June 19, 2012

A request for an amendment to the Conditions of Certification for SEGS VIII Harper Lake (88-AFC-1) and SEGS IX Harper Lake (89-AFC-1) located at 43880 Harper Lake Road, Hinkley, CA 92347 follows.

Attachment 1

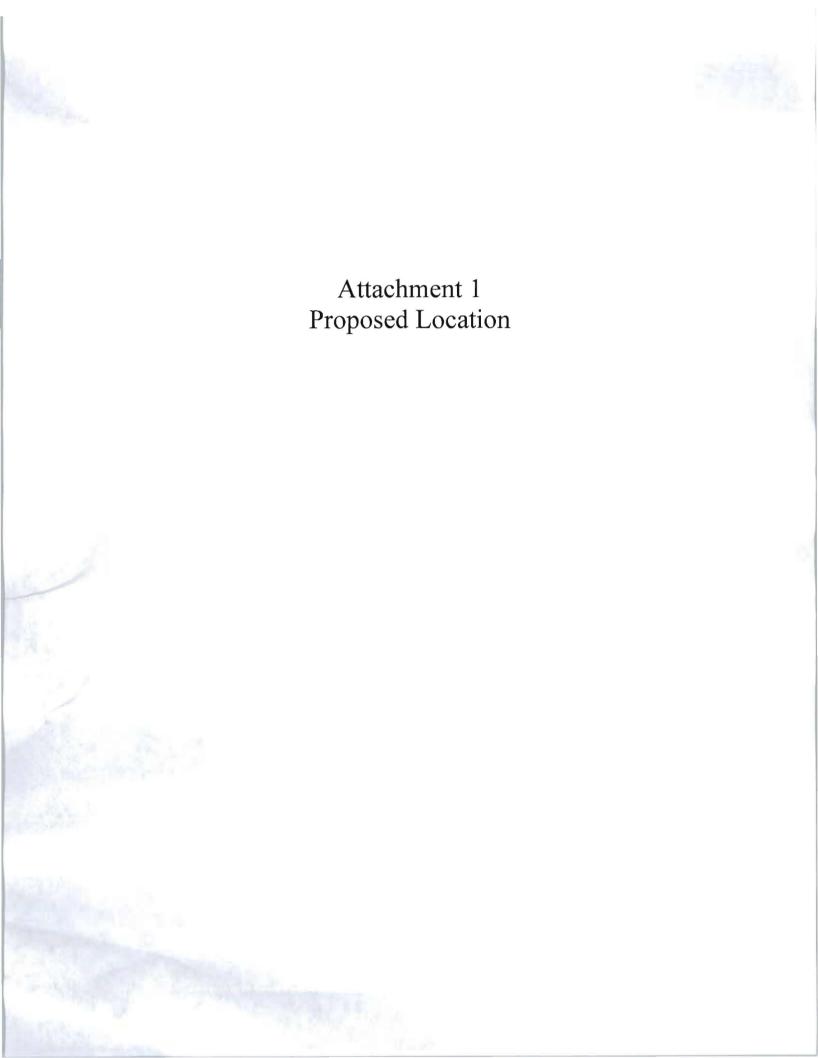
- 2. Description of the proposed modification: NextEra Energy is proposing to construct a foundation and containment structure for storage of a spare main power transformer to be located at the north end of the facility between the two solar fields (Attachment 1). The spare transformer will be purchased this year and will be stored at the facility in the proposed containment structure. Transformers of this size and configuration are special order and require a considerable lead time. In order to improve the plants reliability we are purchasing a spare transformer to be ready and available on site in the event of failure of either one of the two existing main power transformers. This would allow us to minimize any plant downtime in the event of such a failure. The foundation and containment structure will be approximately 25' by 25' in size and will include lightning protection as well as connection to the existing grounding grid. The foundation and containment structure would be constructed in compliance with existing laws, ordinances, regulations and statutes.
